Independent Assessment of Conduct of Operations at the Hanford Site Waste Treatment and Immobilization Plant

May 2024

Office of Enterprise Assessments
U.S. Department of Energy

Figure 1 – Examples of tags with truncated text

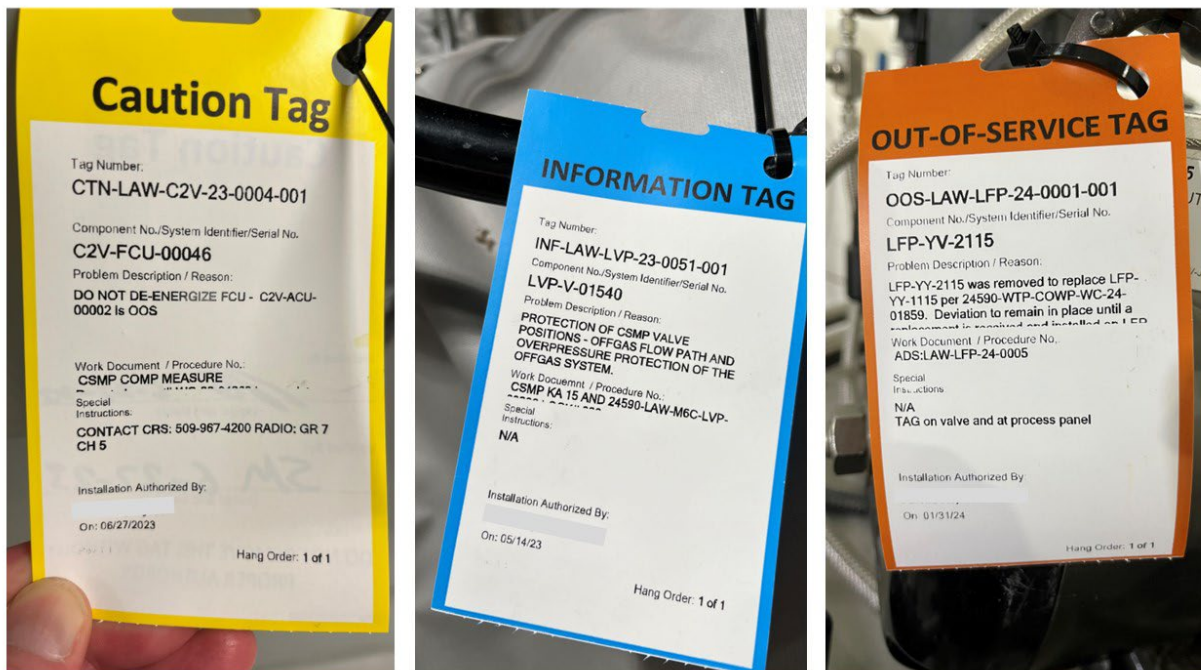
The BNI/WTCC caution and miscellaneous tag program is governed by 24590-WTP-GPP-RACO-CO-0019, *Caution and Miscellaneous Tags*, which implements the requirements of DOE Order 422.1, attachment 2, requirement 2.i.(2). A walkdown of active tags in LAW demonstrated that BNI/WTCC is generally implementing the requirements of 24590-WTP-GPP-RACO-CO-0019. A sampling of tags (approximately 20) was walked down to verify the presence and condition of the tag, serial number, description, proper use, status, and agreement with the tag log, and some discrepancies were observed. First, several tags contained truncated information, limiting personnel's understanding of tag information, including problem description and work document number (see figure 1). Contrary to 24590-WTP-GPP-RACO-CO-0019, section 6.3.4.d, BNI/WTCC does not ensure that all tag information is verified to be legible and complete. (See **Deficiency D-BNI/WTCC-5** and **OFI-BNI/WTCC-6.**) Illegible tags could result in the miscommunication of important information related to equipment operability and safety. Second, two tags (information tag I-19-060 and caution tag O-191-2) had serial numbers that could not be

found in the tag log. Third, tags I-19-060 and O-191-2 had identification numbers that were inconsistent with the numbering convention generated by eSOMS. Finally, LAW has a significant number of legacy tags, including caution tags, quality assurance hold tags, and out-of-service tags, that could impact startup readiness. (See OFI-BNI/WTCC-7.)

OFI-BNI/WTCC-7: Consider developing a strategy to evaluate all hanging plant tags prior to the operational readiness review.

Figure 2 – Valve LOP-V-10094 is beneath the orange foreign material exclusion (FME) cover. The label identifying the valve is on the removed cover plate, circled in red.

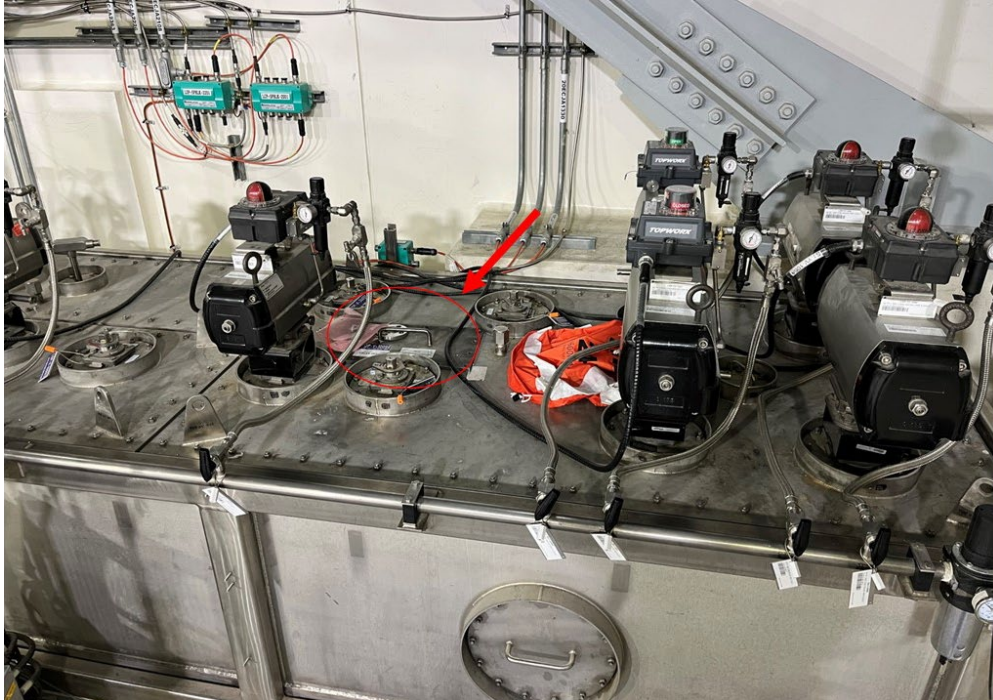
- The label identifying needle valve LOP-V-10094 was affixed to a cover plate that had been removed, so there was no fixed identification of the valve (see figure 2). Operators did not verify that the designator of the valve to be manipulated matched the valve specified in the work instruction prior to valve operation.

Figure 3 – Temporarily installed hose/fitting assembly on LOP-V-10094. The valve operator for needle valve LOP-V-10094 is circled in red (behind the hose/fitting assembly). The valve operator for the temporary ball valve is the yellow handle in the foreground.

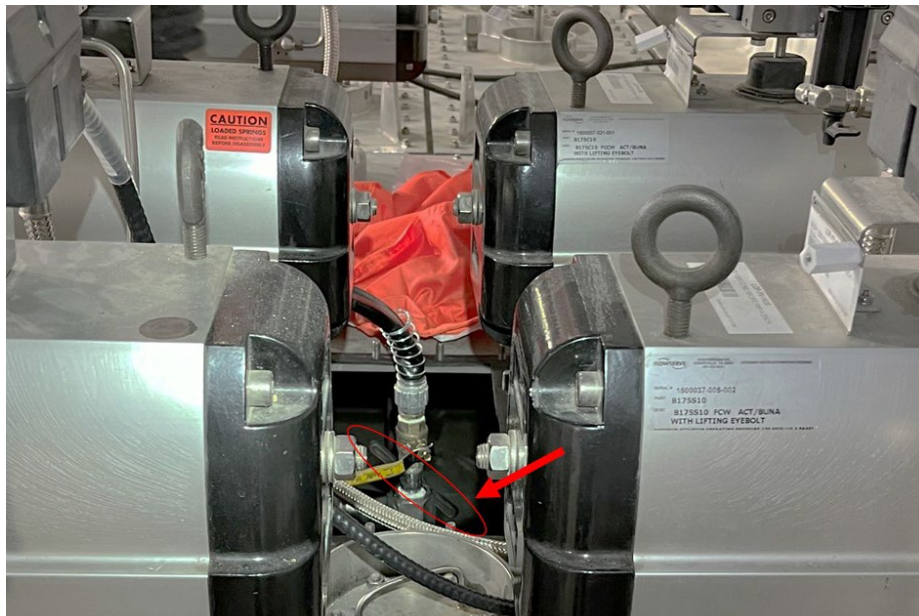
- The temporary ball valve that the operator was improperly using to throttle sample flow was part of a hose/fitting assembly that the SOM stated had been installed under step 4.4.5 of 24590-WTP-COWP-WC-23-05123, which allowed for the use of unspecified “extra fittings...for ease of sampling” (see figure 3). However, this step had been marked not applicable (“N/A”) in the field copy of the work instruction.

- The temporarily installed hose/fitting assembly had been left installed for an extended period of time and was not tracked as a temporary modification or otherwise identified with a tag or label to provide operators with information about its purpose or operation.
